From: Tilly Whishaw [REDACTED]
Sent: 22 July 2021 11:52
To: Simon Davis; Craige Burden
Cc: Daniel Vick
Subject: RE: Y/76/21/DOC Condition 5 Flint Walls
Attachments: 783-DET-002.pdf

From: Simon Davis
Sent: 21 July 2021 12:46
To: [REDACTED]
Cc: Daniel Vick <Daniel.Vick@arun.gov.uk>; Martyn White <Martyn.White@arun.gov.uk>
Subject: Y/76/21/DOC Condition 5 Flint Walls

SITE PLAN 1:200

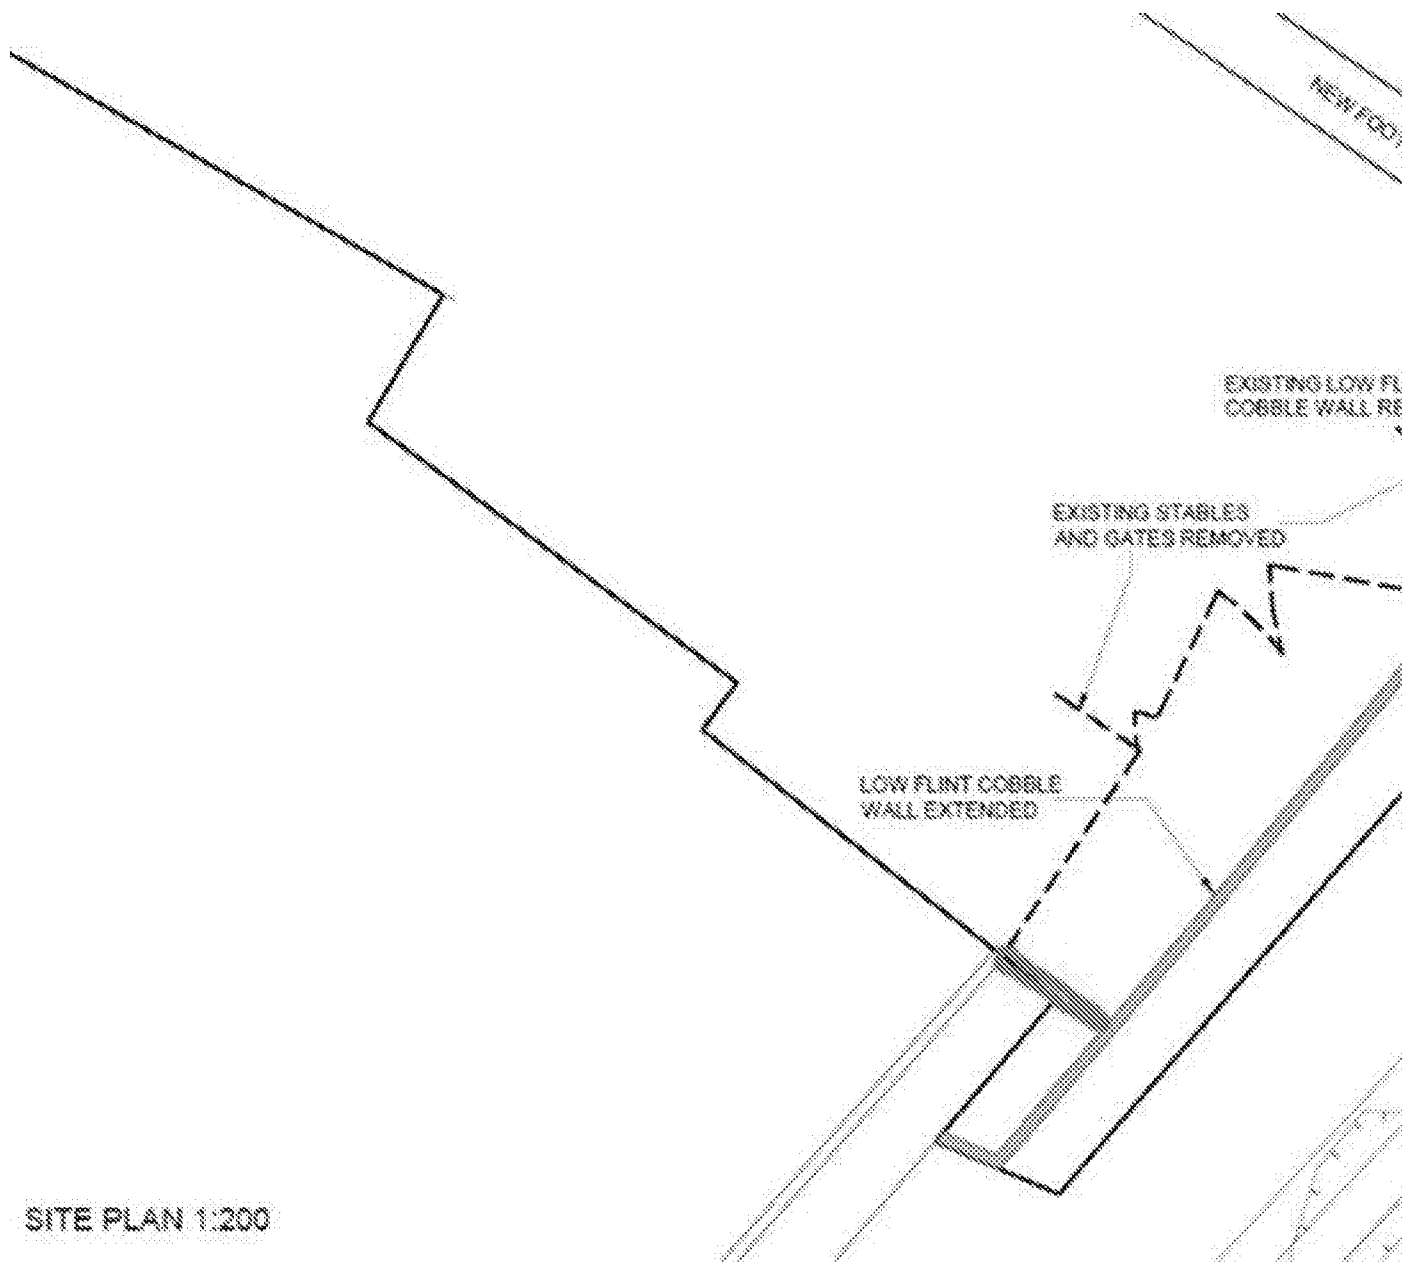
The short answer is there will be a gap. The reason for there being a gap is this is land that is outside the consent for the site and is not on land owned by Redrow Homes (so we can't build the wall)

"The design of the flint wall seems to be generally acceptable and appears to replicate the existing wall. However, it is not clear how the southern end of the new section of flint walling will connect back to the neighbouring walling. At present, it looks as though the new section of wall terminates in front of, but not connected to, the neighbouring flint wall. Is this correct. If so, it will leave a section without any walling. Please can this be clarified."

Martyn White has said that the alternative approach of reducing the length and tying it into the existing wall seems a logical and acceptable approach. Can you therefore revise the plan and send to me, copying in Daniel.Vick@arun.gov.uk please.

The alternative is the wall is reduced in length and ties into the existing wall (see extract below).
